## **Poynton Town Council Response to Planning Application 23/4152M – Poynton Pool Dam Embankment**

This document is in response to the Technical Memorandum Note prepared by Jacobs and should be read in conjunction with the Town Council’s previous submission.

Figure 1-2: Poynton Lake Reservoir General Arrangements

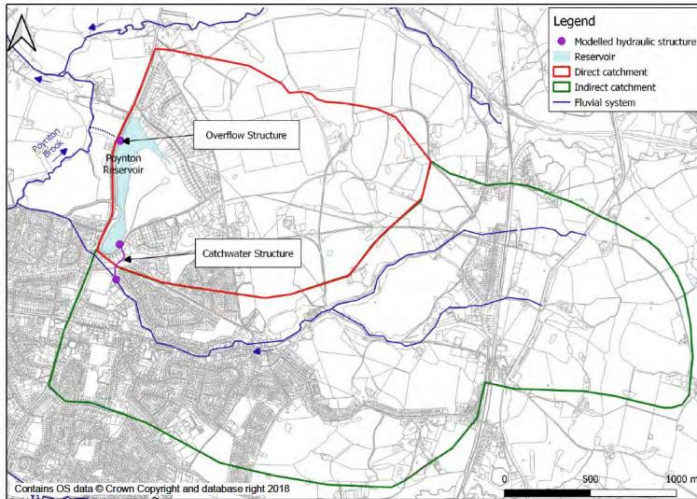
It is incorrect to state that the information for the catchment was extracted from a publicly available map. The map of the catchment on the Centre for Hydrology and Ecology is shown below

However, Jacobs have used the following catchment map

Which differs significantly from the publicly available map.

Figure 2 Hydrad Image; 11th June 2016

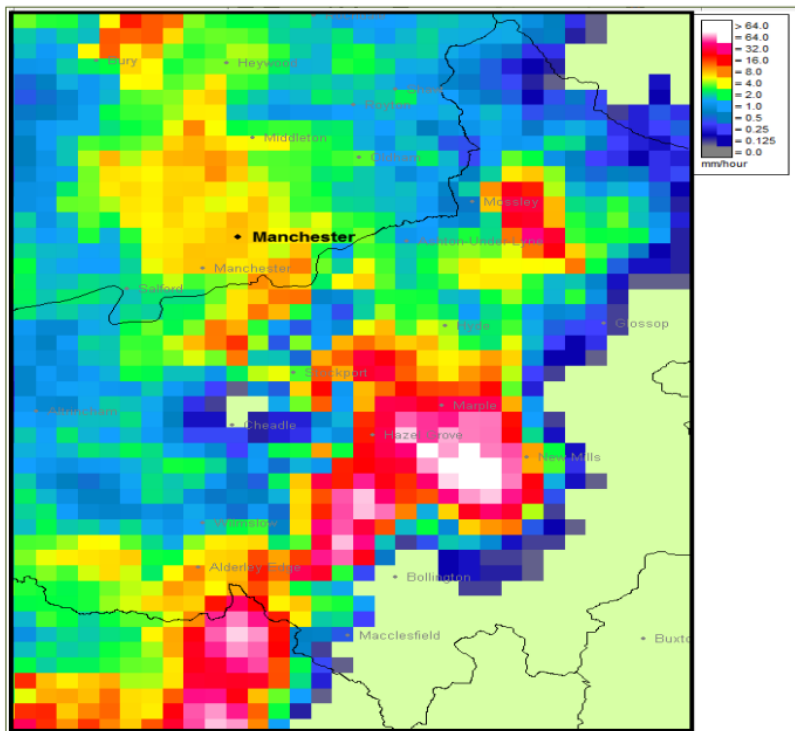
In addition, there were two significant flooding events exceeding the 1% AEP in 2016. Areas G and H which experience flooding are identified in the s19 report are partially within the Poynton Pool Catchment Area (as defined by Jacobs but interestingly not within the smaller catchment area cited on the Centre for Ecology and Hydrology)

From the hydrad image it is clear to see that this rainfall fell within the catchment

The antecedent conditions were “In summary, the available data indicates that the ground conditions were heavily saturated and more saturated than average in June 2016 in the Poynton area. These saturated ground conditions mean that more surface water runoff than typical for the time of year would have been generated for any given rainfall event, with a greater potential for rapid surface water flooding and prompt increases in river levels.”

As with the extreme event in 2019 there were no reports of overtopping at Poynton Pool. Within living memory no one can recall the Pool overtopping despite 26 floods happening in Poynton between 2011 and 2017.
